APPLICATION NO.	FILING DATE	FIRST NAMED INVENTOR	ATTORNEY DOCKET NO.	CONFIRMATION NO.
10/812,324	03/28/2004	George H. Gibbens III	6541-0403	2688

Office Action Summary

DETAILED ACTION

This Office Action is in response to Applicant's amendment filed on 4 December 2006.

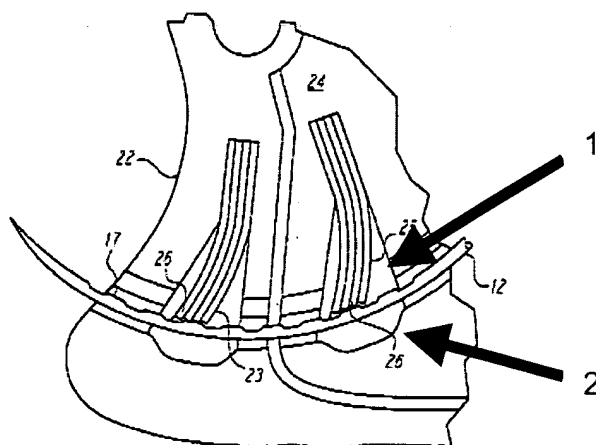
8. Claim 1: Taylor'727 discloses a suturing device that contains a curved needle (12); a first plurality of one-way engaging devices (25, 25) that selectively engage the curved needle (see Figure 7, 7a and column 3, lines 30-65); an arcuate reversing housing (16) that is concentrically positioned around the curved needle for changing the direction of the engaging device (Figures 1, 7, 7a); and an arcuate driver (24) that is concentrically positioned within the arc of the curved needle. The arcuate driver moves along a path (column 4, lines 55-57) and is adapted to pivot the plurality of engaging devices to engage the needle (column 3, lines 30-35 and column 4, ines 53-63). The arcuate driver also has a plurality of circumferentially spaced cavities (see arrow 1 in the Figure 7a below). The engaging devices are contained within the cavity (see Figure 7a). Further, Taylor'727 discloses a fixed way (22) that provides a path for the arcuate driver.

11. Claim 5: The arcuate reversing housing also contains a plurality of spaced cavities for the first plurality of one-way engaging devices (see arrow 2 in the figure for claim 1 rejection above).

12. Claim 4: Taylor'727 discloses a method of surgically suturing (column 1, lines 5-15) that includes providing a driver (24) having a cavity (see arrow 1 in figure for claim 1 rejection); providing a blade (25) with a slot (movement of flexible fingers 26 creates slots for engaging; column 3, lines 30-49) wherein the blade is mounted within the cavity (see Figures 7, 7a). Next, pivoting the blade within the cavity engages the interior surface of the slot and the needle (see Figure 7a). Next, the blade is driven in a first

13. Claim 6: Taylor'727 discloses a suturing device that contains a curved needle (12) and an arcuate driver (24) that is positioned within the arc of the curved needle. The arcuate driver moves along a path (column 4, lines 55-57) and has a first plurality of circumferentially spaced cavities (see arrow in the figure above for Claim 1 rejection). Further, the device contains a plurality of blades (25, 26) carried within the cavities of the driver. One end of each blade is received within the cavity (see arrow 1 in the figure for Claim 1 rejection above). There is also an arcuate reverser (16) is positioned around the curved needle. The reverser also has a second plurality of circumferentially spaced cavities and part of the blade is place within these cavities (see arrow 2 in the figure for Claim 1 rejection above).
